**Public Participation Summary**  
**March 2020 Permit Modification**  
**Utah Groundwater Discharge Permit No. UGW370004**  
**Energy Fuels Resources (USA) Inc.**  
**White Mesa Uranium Mill**  
**San Juan County, Utah**

## **Introduction:**

## **Division General Comment/Response Regarding Permit GWCL Modification Requirements and the use of Intrawell Statistical Evaluation:**

Attachment 1 – Approved Statistical Flow Chart (Groundwater Data Preparation and Statistical Flow for Calculating Groundwater Protection Standards, White Mesa Mill Site [INTERA, 2007])

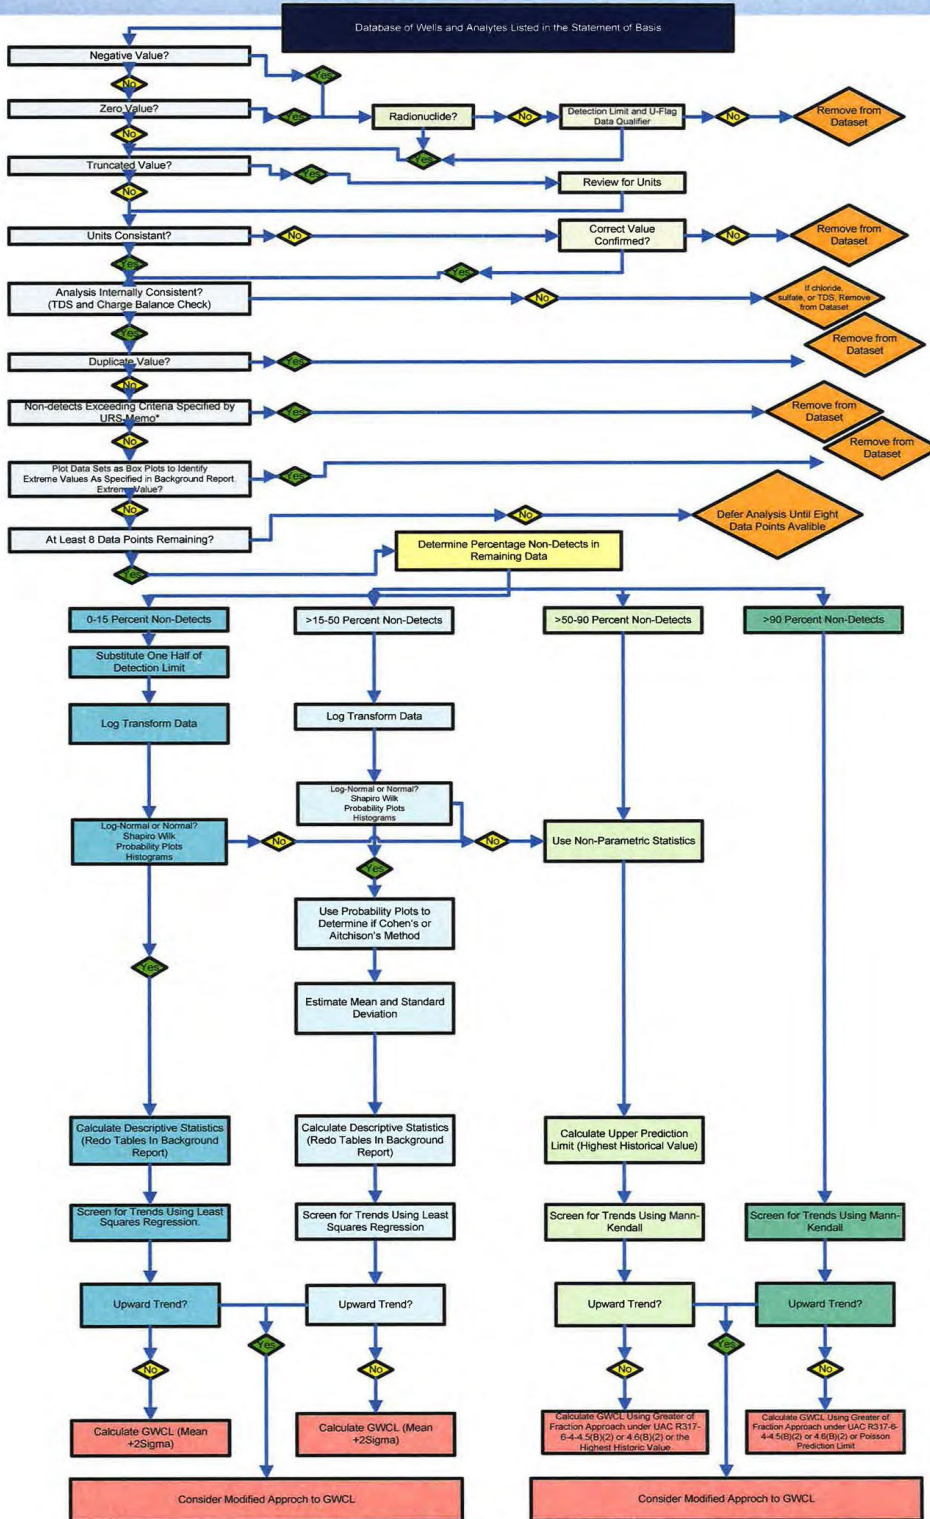
Permit GWCL's included in the Permit are based on intrawell statistics and are performed per a process outlined in the approved flow chart for the White Mesa Uranium Mill (Mill). The flow chart was originally based on the EPA Interim RCRA Statistical Guidance which was finalized in March 2009 and titled *Statistical Analysis of Groundwater Monitoring Data at RCRA Facilities Unified Guidance*. EPA 530/R-09-007 (Unified Guidance). A copy of the approved flowchart is included with this public participation summary as Attachment 1.

Findings of the EFR Source Assessment Report for MW-30 and Division Review findings conclusively find that increasing uranium concentrations are not caused by the Mill and that sitewide the concentrations of uranium in MW-30 are very low. Adjustment of the uranium GWCL is warranted and is consistent with Federal and State Rules and Regulations and the Permit. Statistical analysis for the modified uranium GWCL was done in conformance with the approved statistical flow chart. A copy of the approved flowchart is included with this public participation summary as Attachment 1.

Figure 1 UMUT Wind Data from 2016

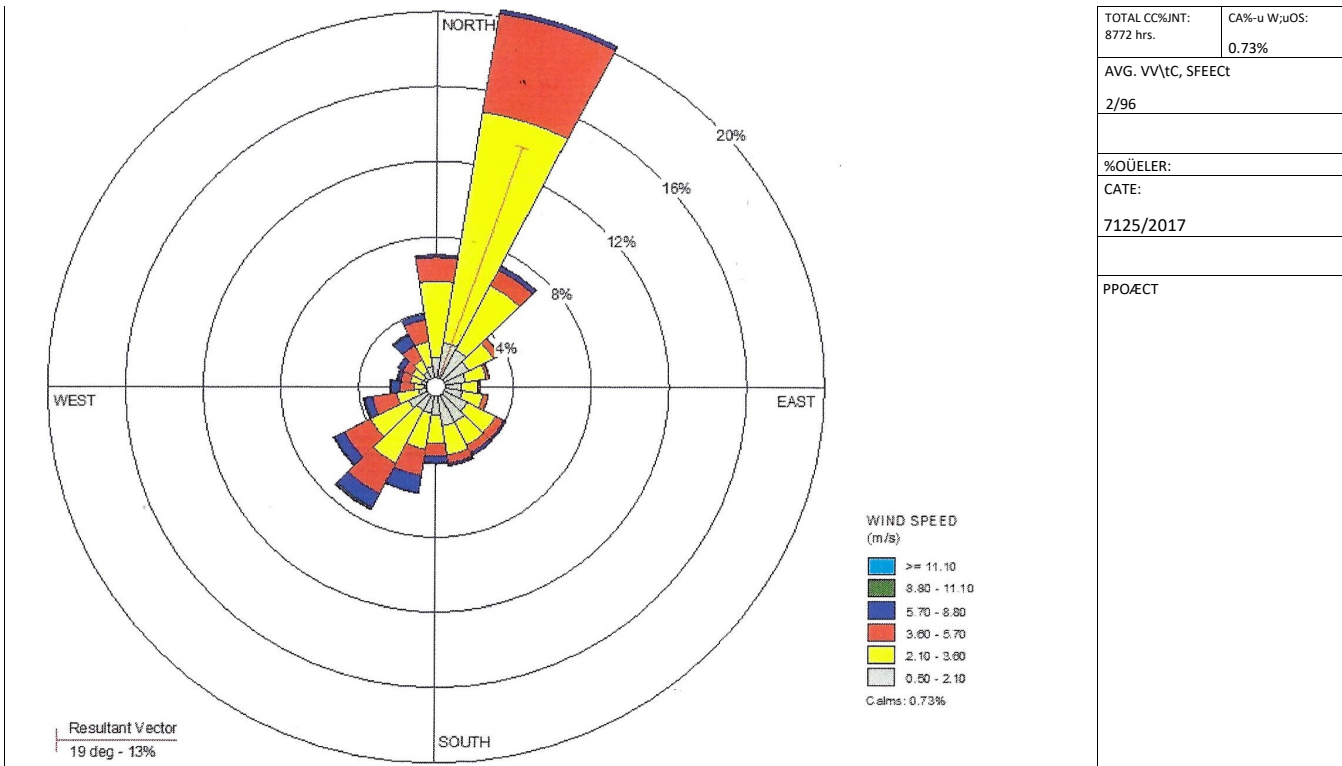
As indicated in the 2017 response to the WMM License renewal, the wind rose below (Figure 1), a compilation of meteorological data from the White Mesa Community, indicated the majority of the calm winds come from several of the northern sectors toward the White Mesa Community and are less than 3.6 m/s or 8 miles per hour. This same observation has been documented in the WM Mill's own data files Figures 2-6 (taken from Appendix C to the EFR's 2018 Cells 5A and 5B License and GWDP Amendment Request which are presented below). The windroses present the exact conditions of low speed drainage winds, which are cautioned by the NRC as those that pose the most risk or highest radon concentrations. These low speed winds impact the White Mesa Community and members and visitors sense these impacts through the smell of surrogate organic fumes that, unlike radon, can be experienced by the human population.

Figure 8: Cadmium/pH cross plot data for wells is from the 1<sup>st</sup> Quarter 2020 Quarterly monitoring report

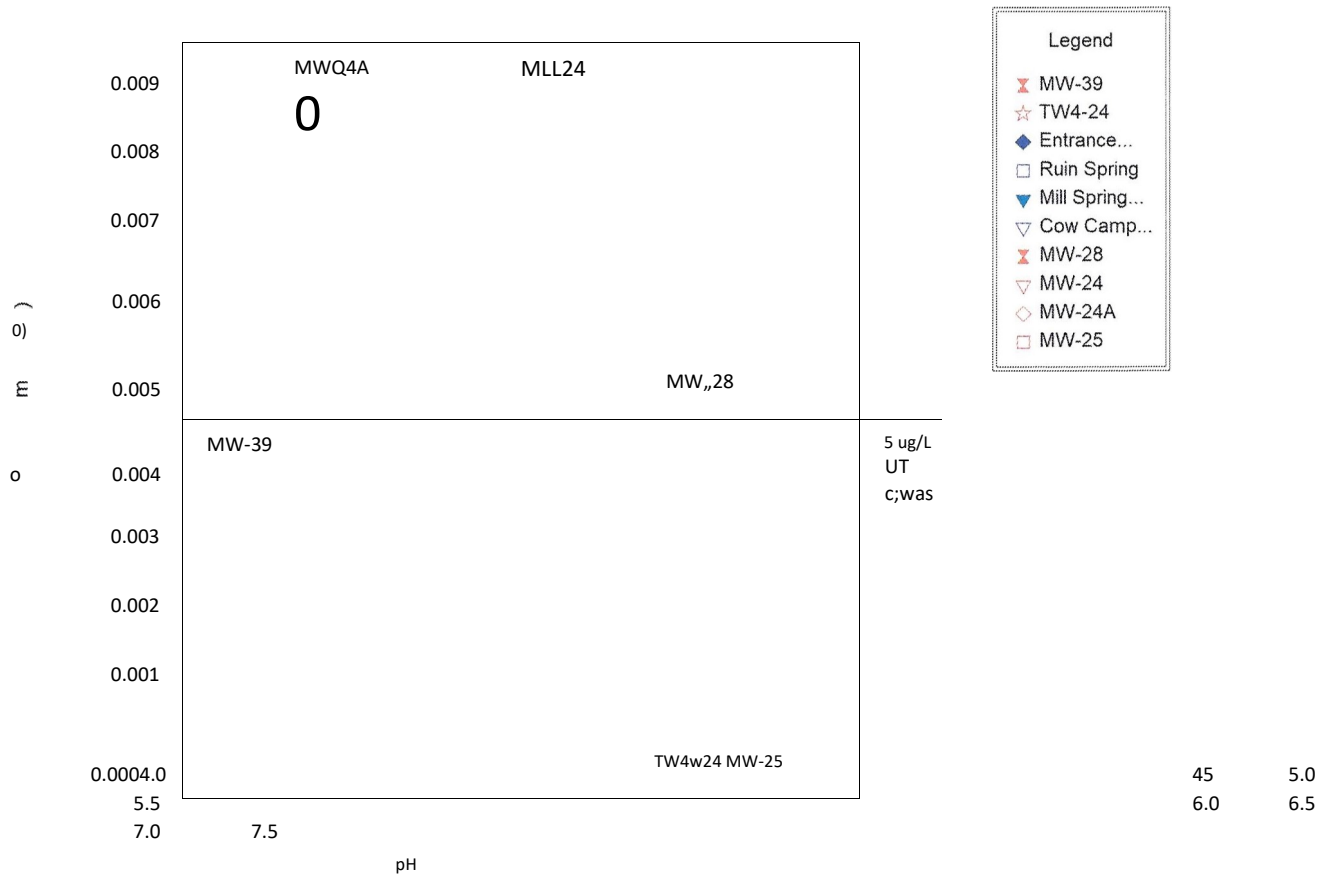
*UMUT Comment 28.a. – Cadmium is an indicator parameter of facility impact to the groundwater. Raising the GWCL for cadmium in MW-25 will conceal continuing facility releases and impact to the Burro Canyon aquifer. MW-25 is now the fifth well which shows rising trends of Cadmium at concentrations greater than 1.5 ug/L (Map 1) and is on the way to joining MW-22, MW-24/MW-24A, MW-28 exceeding health-based water quality standards (UT R-317-6). [Figure not included]*

**Division Response:** The Division disagrees with this comment because it is not supported by the technical evidence in the Administrative Record. The current Permit modification includes a GWCL modification for cadmium only at MW-25. Per findings, the MW-25 cadmium data is normally distributed and no increasing trend is evident. [Figure not included]

Figure 9: Piper Diagram: 1<sup>st</sup> Quarter 2020 Groundwater Data

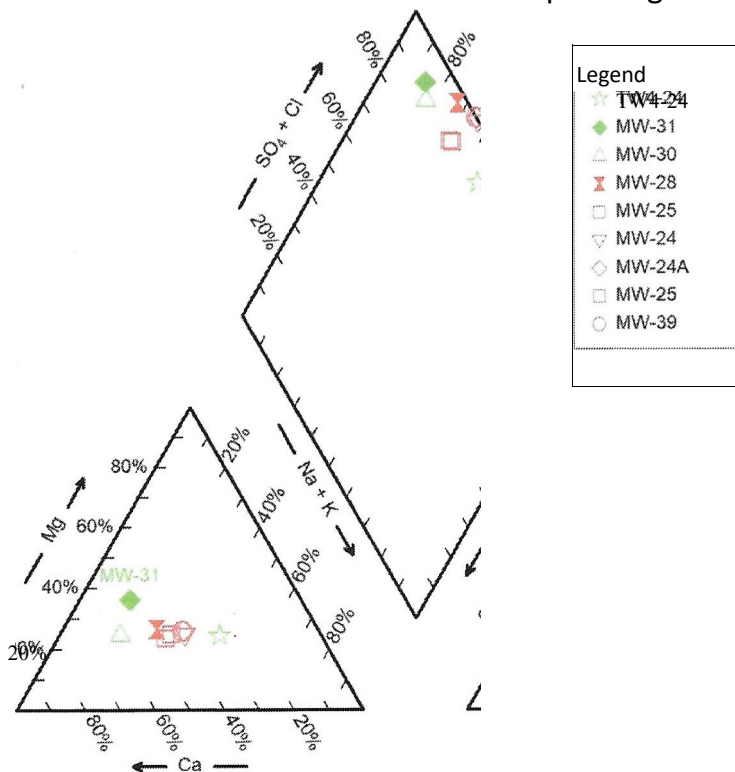
*UMUT Comment 28.b. – The water chemistry at MW-25 places it in a group with five wells which are exhibiting rising trends in cadmium with a corresponding decline in pH. This group is distinguished by an ion signature [sic] elevated in sulfate and depleted in sodium and alkalinity compared to monitoring wells completed in the nitrate and chloride plume like MW-30 and MW-31. TW4-24 has been revealed to have extremely elevated and dangerous concentrations of uranium (663 ppb, 05/17/2018) after we requested the well be screened for the full analyte table in the GWDP during a previous re-licensing action also has a distinct ion signature and should be required to be investigated with isotopic testing to calculate the activity ratio for uranium isotopes to determine conclusively if it is associated directly with the mill facility.*

b The water chemistry at MW-25 places it in a group with five wells which are exhibiting rising trends in cadmium with a corresponding decline in pH. This group is distinguished by an ion signature elevated in sulfate and depleted in sodium and alkalinity compared to monitoring wells completed in the nitrate and chloride plume like MW-30 and MW-31. TW4-24 has been revealed to have extremely elevated and dangerous concentrations of uranium (663 ppb, 05/17/2018) after we requested the well be screened for the full analyte table in the GWDP during a previous re-licensing action also has a distinct ion signature and should be required to be investigated with isotopic testing to calculate the activity ratio for uranium isotopes to determine conclusively if it is associated directly with the mill facility.

Stiff Diagram: MW-24, 1st Quarter 2020

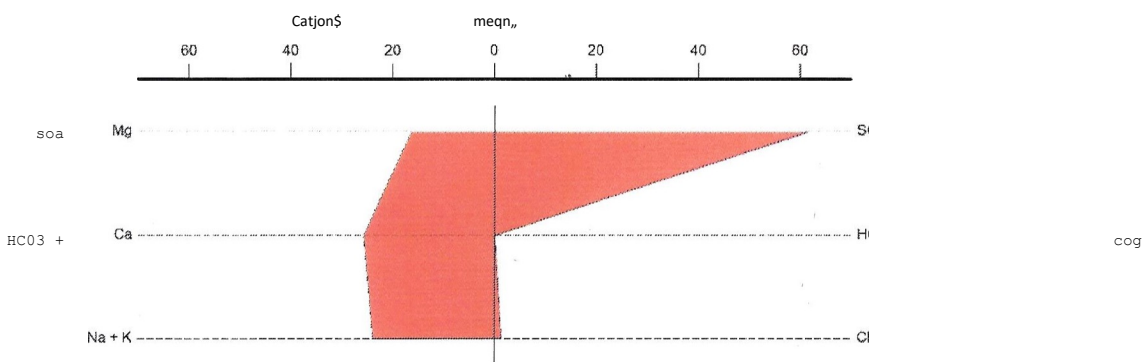
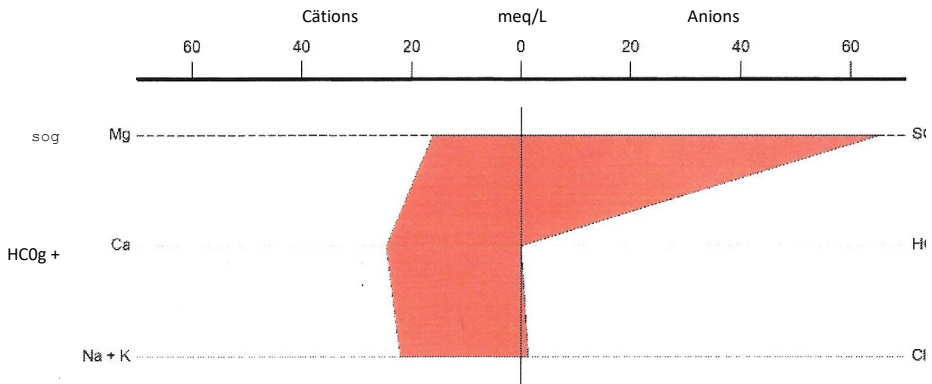
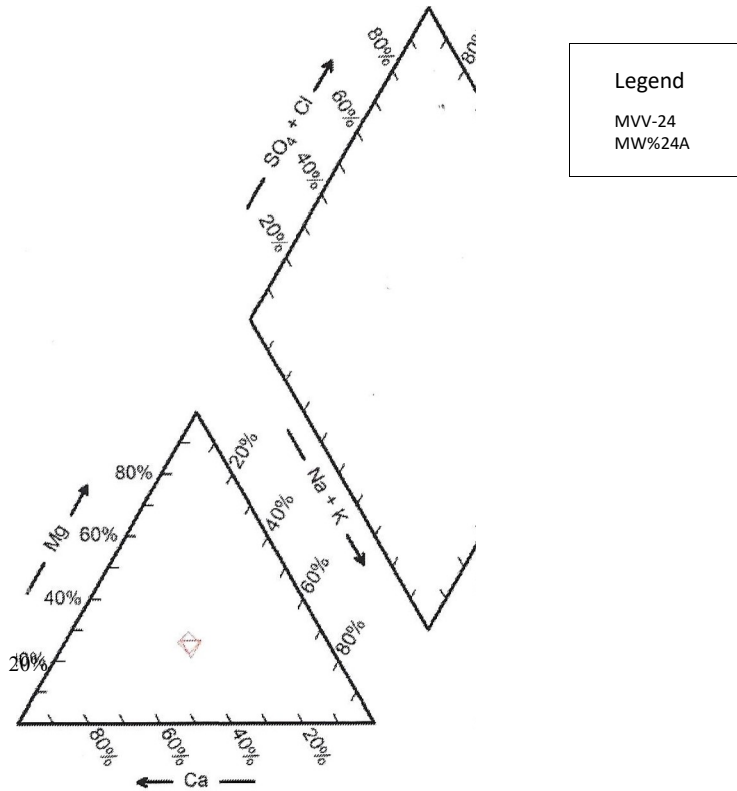
*UMUT Comment 31. – New Well MW-24a is chemically identical to existing Well MW-24 and there is no need to spend two more years collecting data to develop new GWCL for new well MW-24a. The existing GWCL for MW-24 should be used to recognize the exceedances at this location as a POC well for old outdated cells 1 and 2. MW-24 is associated chemically with a signature of facility impact as discussed in our Comment #1. The Director is proposing to allow EFR more than two years to collect data from a new well, MW24a, as they explore if a well construction issue is to blame for the rise in specific ions and metals in MW-24 (See Comment #1, MW-24 fits in a group with MW-25, MW-28, MW-39 and MW-22). Data from the first quarter 2020 first sampling event show water chemistry in MW-24a is obviously similar to that in MW24 (Stiff diagrams, piper diagram and comparison table below from the 1st Quarter 2020 Groundwater Monitoring Report). There is no need to wait for additional quarterly samples, and it makes no sense to delay for two years. Water chemistry trends in MW24 are confirmed. The trends at this location fit into a distinct pattern with other site wells including MW-25, which indicates an anthropogenic continuing source from the Mill site. A source ID requirement for cadmium sitewide needs to be conducted and must include updated comprehensive geochemistry and isotopic tests for all POC wells and general monitoring wells along with TW4 and TWN series wells to conclusively determine the sources of the recognized nitrate chloride plume which is associated with uranium concentrations far above health based standards (TW4-24, 663 ppb 05/17/2018), the chloroform plume which continues to increase in size and concentration (1st quarter 2020 chloroform report) and the cadmium plume associated with cobalt, nickel, molybdenum, thallium, beryllium and manganese. [Figures not included]*

**Division Response:** No changes are proposed for monitoring well MW-24, MW-24A, or TW4-24. MW-25 is located at the margin of the chloride/nitrate plume as discussed in the MW-25 Source Assessment Report and the Division Review Memo.
